NORTH BAY AT LAKE WOODMOOR
GRADING & EROSION CONTROL PLAN

PCD FILE NO.: SF263

NORTHBAY AT LAKE WOODMOOR
CONSTRUCTION DOCUMENTS
EL PASO COUNTY, CO

SHEET
GEC
2

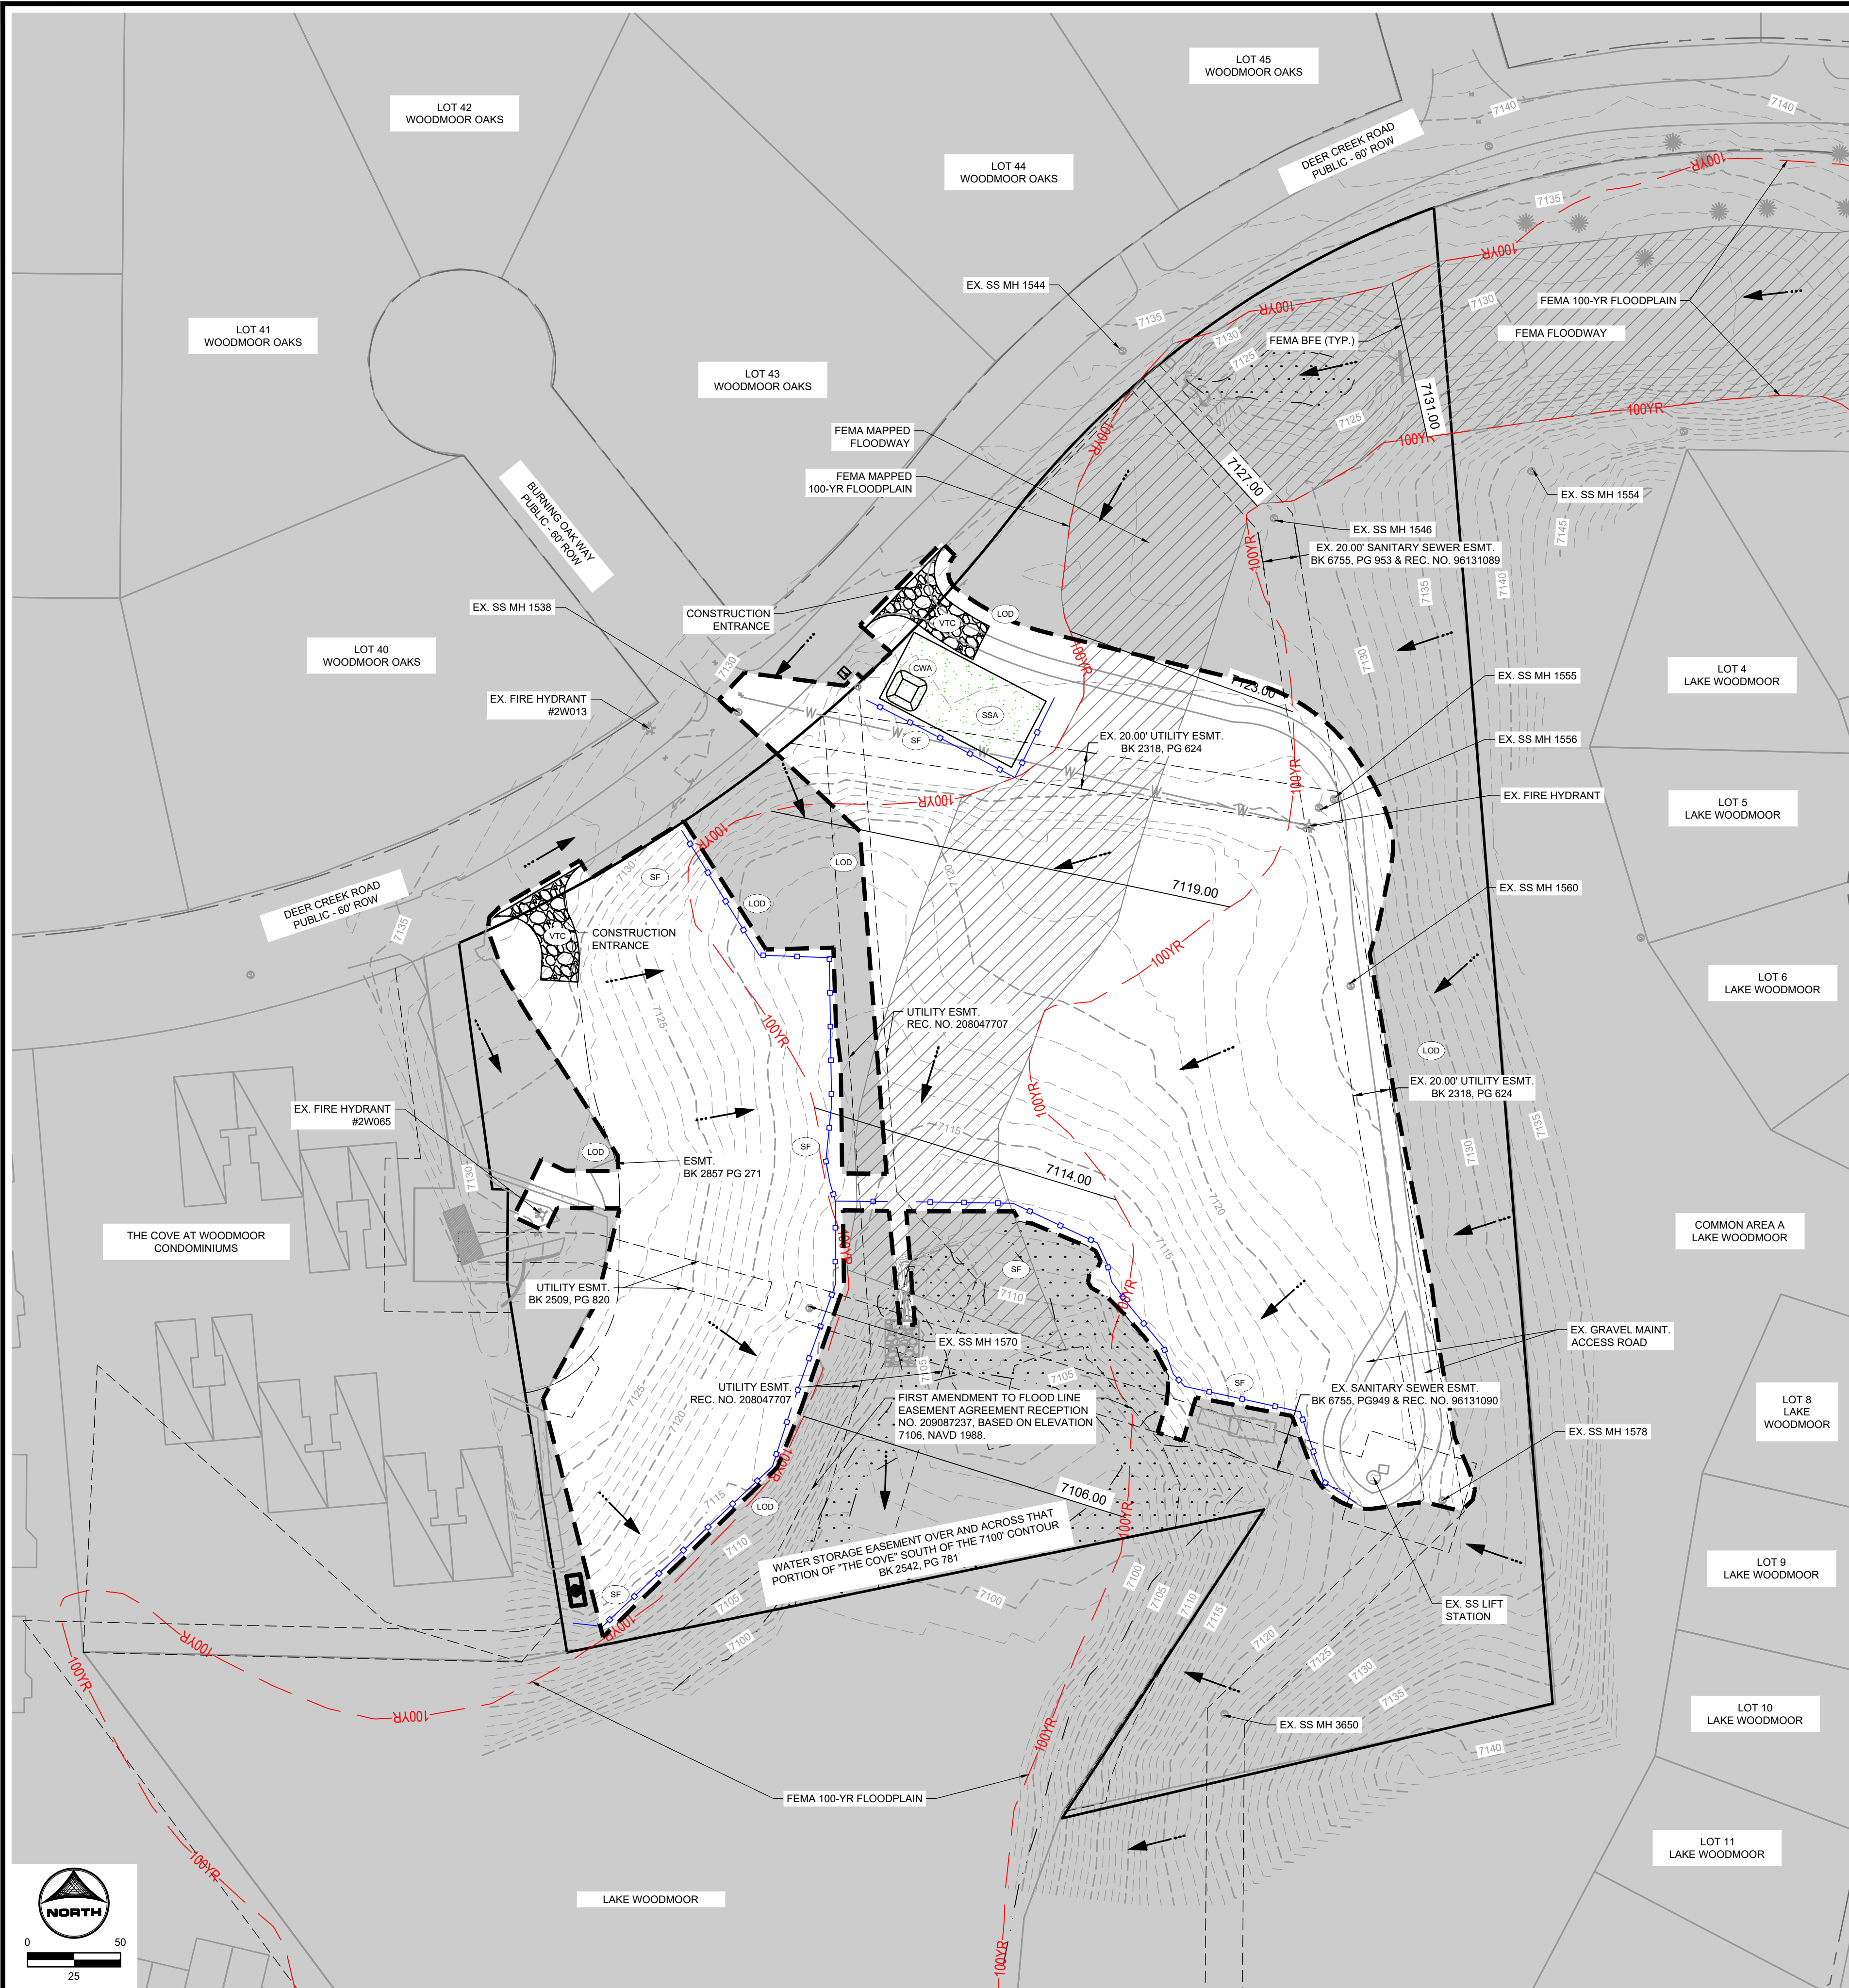
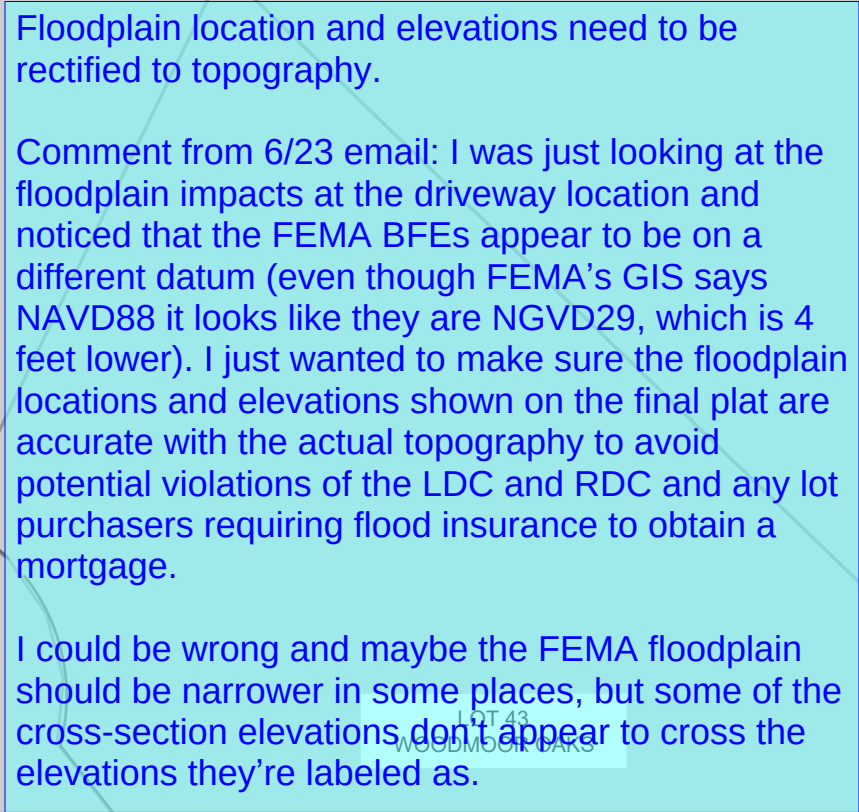
Add abbreviations to legend at right
